James A. FitzPatrick
Nuclear Power Plant
268 Lake Road
P.O. Box 41
Lycoming, New York 13093
315-342-3840

**Response to Requests for Additional Information Regarding Improved
Technical Specification Sections 3.6 and 3.8**

James A. FitzPatrick Nuclear Power Plant
Improved TS Review Comments
ITS Section 3.6, Containment Systems

FIGURE RAI 3.6.4.3-1.1

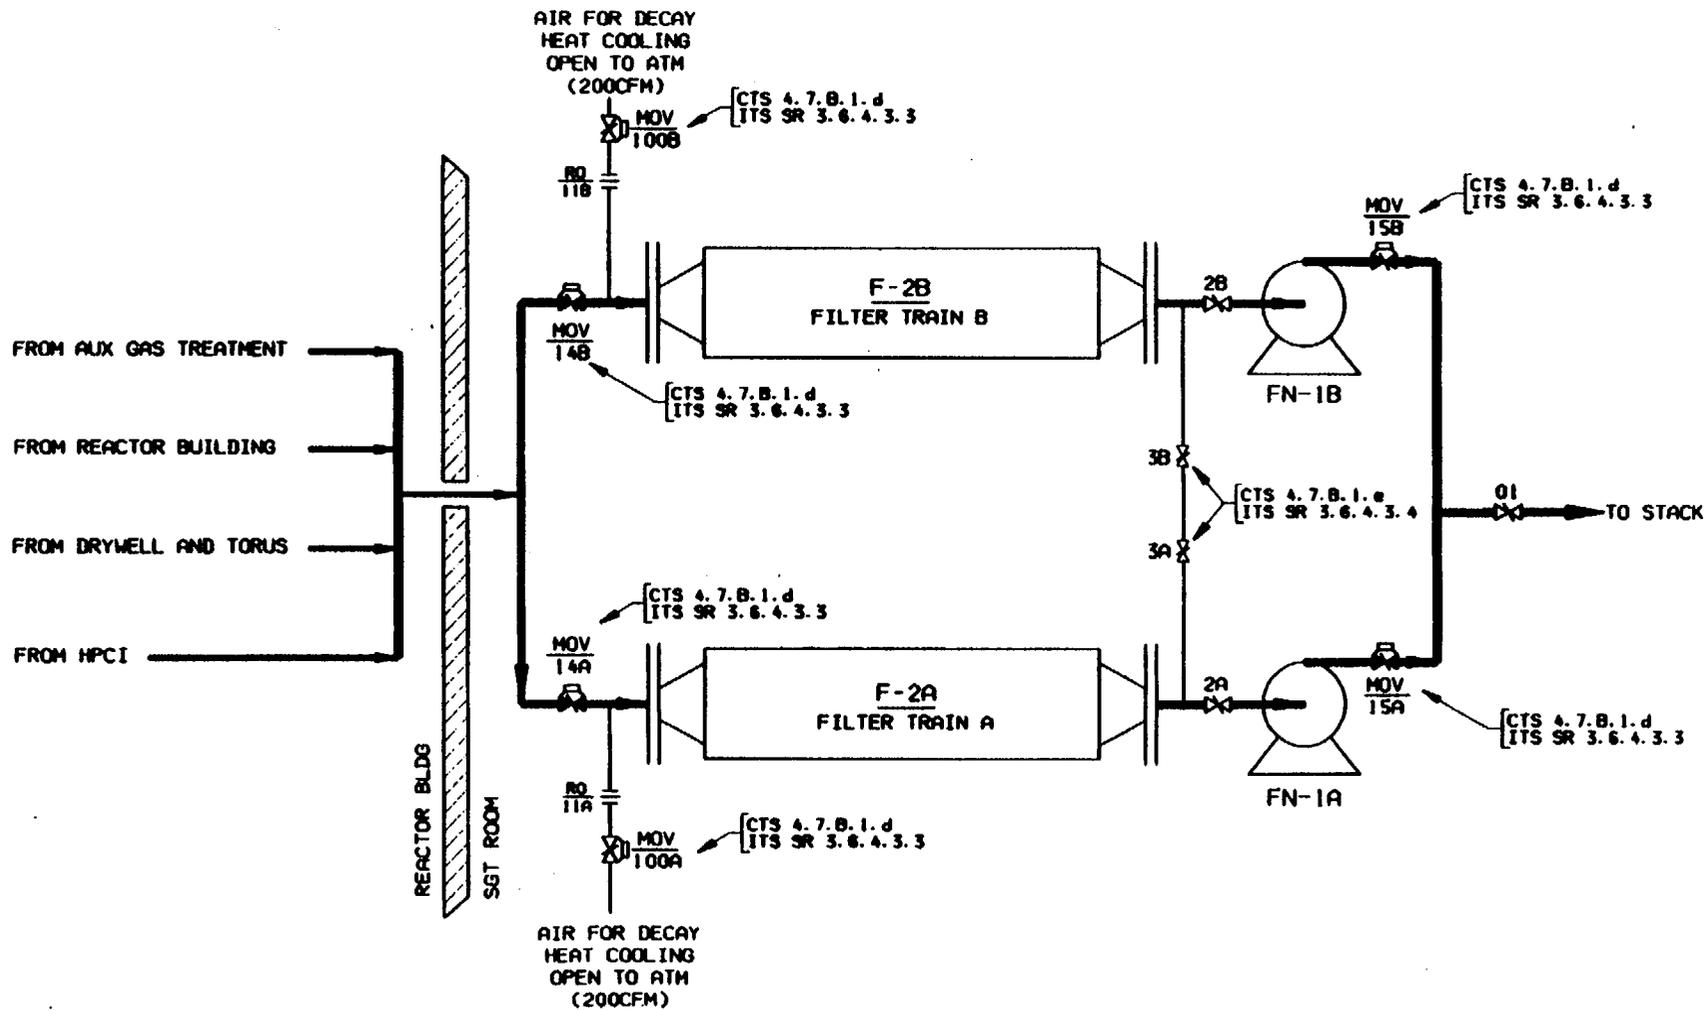
1. Refer to response to item 3.6.4.3-1 and Figures RAI 3.6.4.3-1.1 and RAI 3.6.4.3-1.2
2. As shown on Figure RAI 3.6.4.3-1.1, the manual valves associated with filter decay heat cooling are labeled 3A and 3B. CTS 4.7.B.1.e and ITS SR 3.6.4.3.4 are the applicable surveillance requirements. Valves 3A and 3B must be capable of being full open to provide the decay heat cooling air flow path for the idle subsystem filter (see Figure RAI 3.6.4.3-1.2) and must also be capable of full closure to allow isolation of one subsystem filter for maintenance purposes while maintaining operability of the other subsystem.
3. NYPA will revise the NUREG markup of SR 3.6.4.3.4 to require cycling of valves 3A and 3B as suggested.

1. The following pages contain a simplified diagram of the SGT System with both subsystems in the normal (standby) configuration (Figure RAI 3.6.4.3-1.1) and a simplified diagram showing one SGT subsystem in operation and providing decay heat cooling for the other (idle) subsystem (Figure RAI 3.6.4.3-1.2). Figure RAI 3.6.4.3-1.1 is marked with references to applicable CTS and ITS SRs adjacent to each valve as requested.
